PLANNING & ZONING COMMISSION MEETING

2. A discussion and recommendation to the City Council on a site plan amendment zoning application to an approved major site plan for a data center located at 12901 W Olive Ave, El Mirage AZ 85335, submitted by Jacobs Engineering. (Development Services - Planning and Zoning)

Case Number:	SPA24-02-01	Request:	Site Plan Amendment
Project Name:	MS PHX82 SPA		
Applicant/Owner:	Jacobs / Microsoft Corporation		
Project Address:	12901 W Olive Ave, El Mirage AZ 85335	Acres	137.0 ac

To: Lisa Amador, Jacobs Engineering.
From: Jose A. Macias, Senior Planner
Development Services Department, Planning & Zoning
Re: SPA24-02-01 PHX 82
Date: March 14, 2024

SHEET NAME
SITE PLAN EXHIBIT
SHEET NUMBER
C-C-002

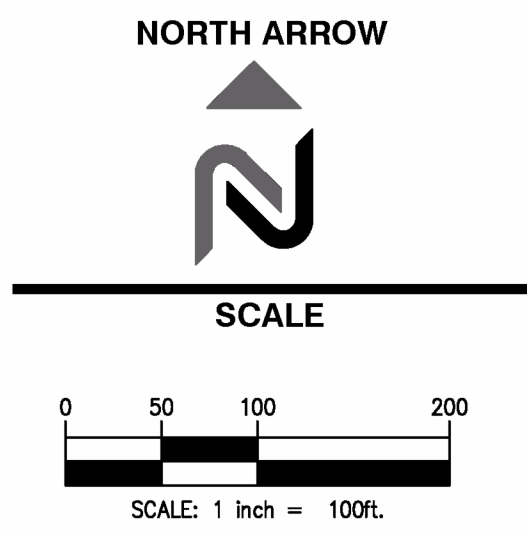
3	Bryce Christo	SITE PLAN	Provide a larger scale version that focuses the proposed PHX82 improvements	Larger scale site plan focusing on PHX82 improvements now provided as second sheet C-C-002 under site plan exhibit.
4	Bryce Christo	LANDSCAPE PLANS	The City Notes are not the latest version. An AutoCAD version can be provided upon request.	City notes have been updated on cover sheet.
5	Bryce Christo	LANDSCAPE PLANS	Irrigation Plans will be required during the Construction Plan submittal	Acknowledged
6	Bryce Christo	TRAFFIC IMPACT STUDY	The TIS is labeled as “Draft”. A Final version will be required during the Construction Plan submittal.	Acknowledged
